**From:** McDonald, Scott <Scott.McDonald@adm.com>  
**Sent:** Thursday, September 04, 2014 5:09 PM  
**To:** Greenhagen, Andrew  
**Cc:** Rzeznik, Dana; Frommelt, Dean  
**Subject:** RE: IBDP Permit for CCS#1 - Attachment G  
**Attachments:** ADM CCS1 ATTACHMENT G Construction Details v3 slm.docx; IBDP CCS#1 Well Design Final.xlsx

# **IBDP CCS#1 Well Schematic** (depths are reference to the Kelley bushing = 689 ft above MSL) KB = 15 ft above ground, site elevation = 674 ft above MSL

## ATTACHMENT G: CONSTRUCTION DETAILS

Facility name: Archer Daniels Midland, CCS#1 Well  
IL-115-6A-0002

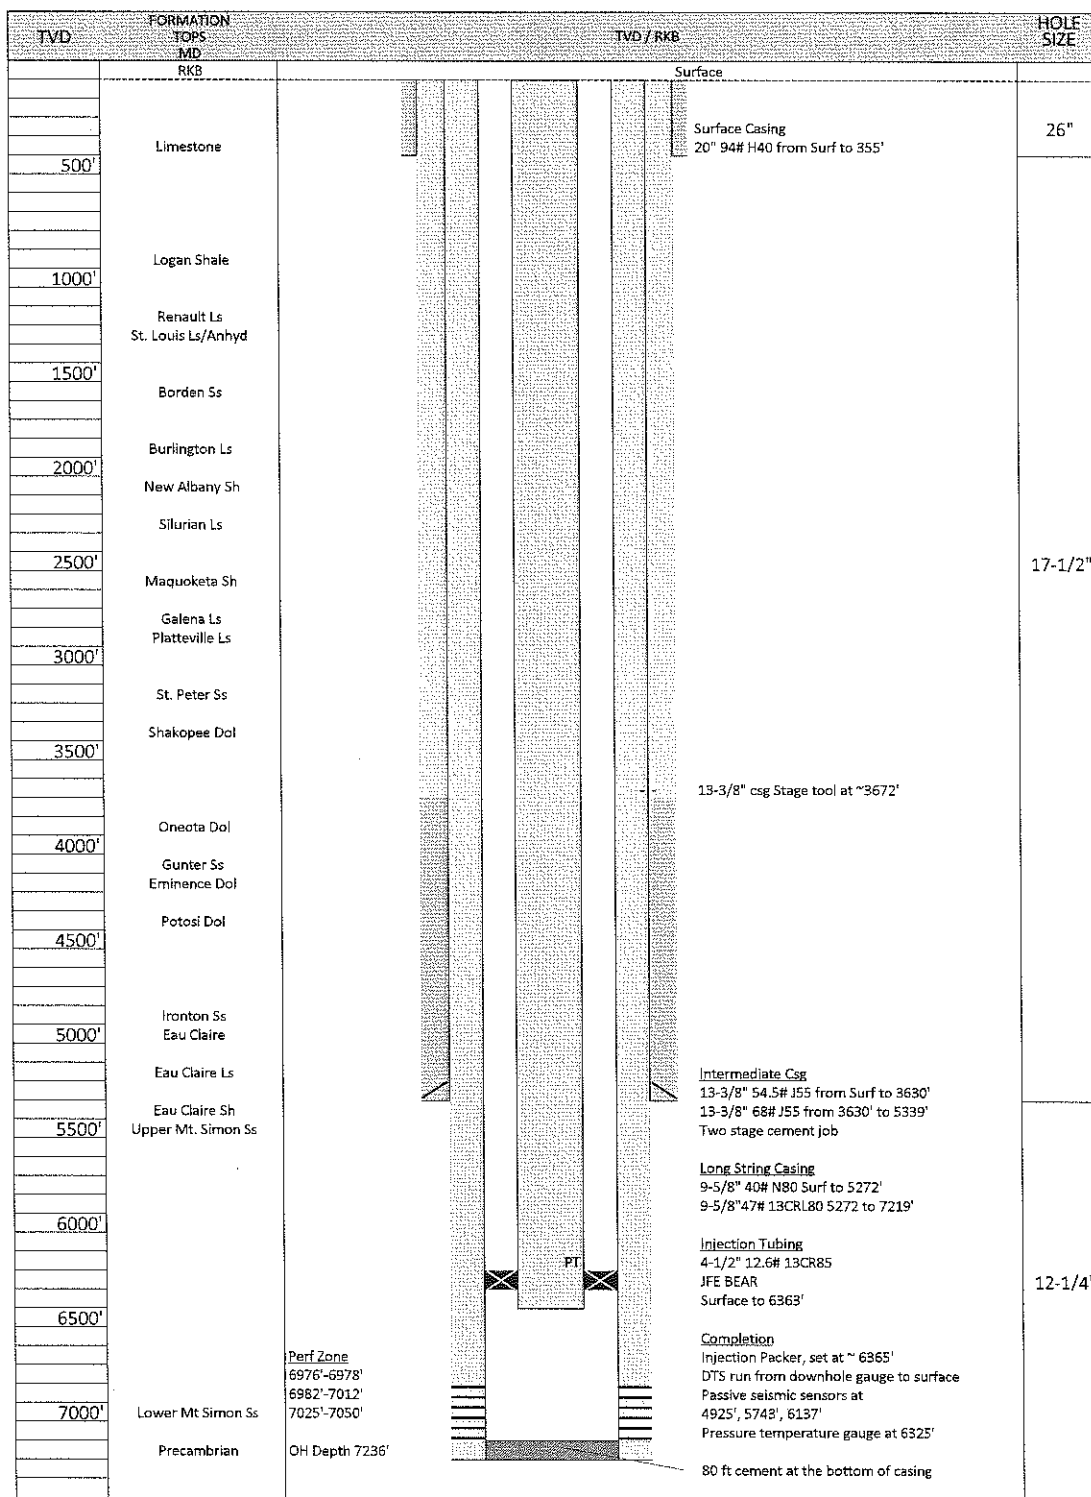
Thanks for sending these. Is it possible for you to more clearly show/label the 80 feet of cement at the bottom of the well on the schematics? We both know it is there, but to make it abundantly clear to the public, I think it would be helpful.

Also, in the text on page 5 it says there are perfs from 6976-6978 and 6982-7050. This doesn't match up with the perfs noted on the schematics which list 6976-6978, 6982-7012, and 7025-7050. It would be great if these were all consistent.

Attached is the finalized well design for CCS#1. All the corrections have been made to the drawing and the text.

The injection well was plugged back from the bottom with at least 80 feet of cement or a greater amount sufficient to prevent the injection fluid from coming in contact with the Precambrian granite basement. The figure below is a well construction schematic for CCS#1.

After the well was cased, three pressure fall-off tests were performed to provide data for the reservoir modeling. Since injectivity testing is best analyzed in a single-phase fluid environment, the gauges were placed near a perforated interval, and then fluid was injected for a period and the pressure fall-off was measured. A total of three pressure fall-off tests were conducted. The first involved injection for 2 hours and monitoring for 19.5 hours; the second involved injection for 5 hours and monitoring for 45 hours; the last test involved injection for 13 hours and monitoring for 105 hours. Also at this time, a step rate test was performed to determine the fracture gradient. The well was perforated between 6,976 - 6,978, 6,982 - 7,012, and 7,025.5 - 7,050.5 feet.
